Modifications for EPIC™ Adapters

Modification for the 8-40 ZIF Adapter (Part # 840Z)

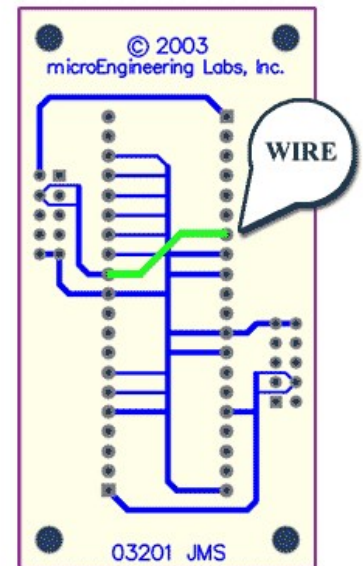
Only perform this modification on adapter revision 03201 or 03221.

Perform this modification if you have trouble programming 28-pin PIC18Fxxx devices that require a AVdd connection on pin 7, such as 18F2331 and 18F2431.

Only change the back (solder side) of the printed circuit board.

Solder a wire between the pins as shown. 26-30 gauge wire-wrap wire can be used.

Modification for the 40/28 ZIF Adapter (Part # 4028Z)

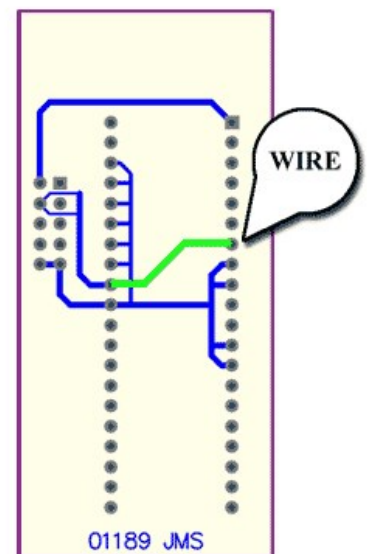
Only perform this modification on adapter revision 95181 or 01189.

Perform this modification if you have trouble programming 28-pin PIC18Fxxx devices that require a AVdd connection on pin 7, such as 18F2331 and 18F2431.

Only change the back (solder side) of the printed circuit board.

Solder a wire between the pins as shown. 26-30 gauge wire-wrap wire can be used.

Modification for the 28-pin SOIC ZIF Adapter (Part # 28SOIC)

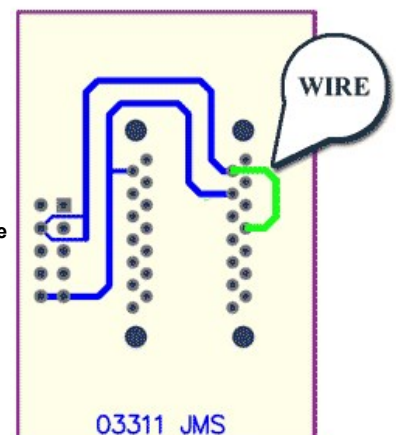
Only perform this modification on adapter revision 03311.

Perform this modification if you have trouble programming 28-pin PIC18Fxxx devices that require a AVdd connection on pin 7, such as 18F2331 and 18F2431.

Only change the back (solder side) of the printed circuit board.

Solder a wire between the pins as shown. 26-30 gauge wire-wrap wire can be used.

Modification for 8/18/20 ZIF Adapter
(Part # 820Z)

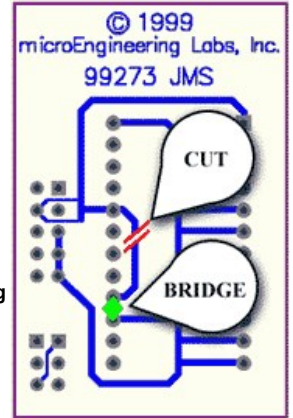
Only perform this modification on adapter revision 99273.

Perform this modification if you have problems programming the 8, 18, or 20-pin PIC16Fxxx or 18Fxxx devices.

Only change the back (solder side) of the printed circuit board.

Cut the trace as shown using a sharp knife or a rotary tool with a small engraving bit. Cut deeply into the board to make sure that the trace is completely severed.

Solder a wire bridge between the 2 pins as shown. 26-30 gauge wire-wrap wire can be used.

Modification for the 40/28 ZIF Adapter
(Part # 4028Z)

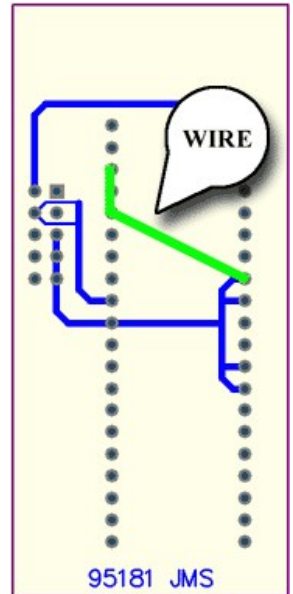
Only perform this modification on adapter revision 95181.

Perform this modification if you have trouble programming the 28 or 40-pin PIC16Fxxx or PIC18Fxxx devices.

Only change the back (solder side) of the printed circuit board.

Solder a wire between the 4 pins as shown (all 4 pins should be electrically connected to one another). 26-30 gauge wire-wrap wire can be used.
